# SERVICE BULLETIN

M-1408F 2017-03-01

## M1408F: 2014-2015 TOURING SADDLEBAG MOUNT - SAFETY RECALL 0166

#### Reason for Revision

Figure 2. Saddlebag Stud Receptacles

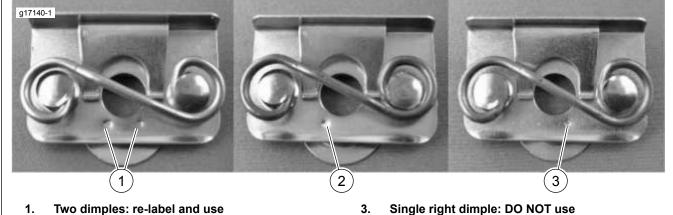
- 1. Verify that the motorcycle is involved in this recall.
- See Figure 2. Remove saddlebags.
- 3. Remove receptacles (1).
  - Insert a small screwdriver between receptacle clip and edge of saddlebag support.
  - b. Pry receptacle from saddlebag support.
- 4. Install new receptacles supplied in kit.
- 5. Install saddlebags using original studs (2) and washers.
- Confirm that stud has been rotated a full 90 degrees to ensure complete engagement.
- When returning the motorcycle, remind the owner of the importance reading and following the saddlebag installation instructions provided in the owner's manual.
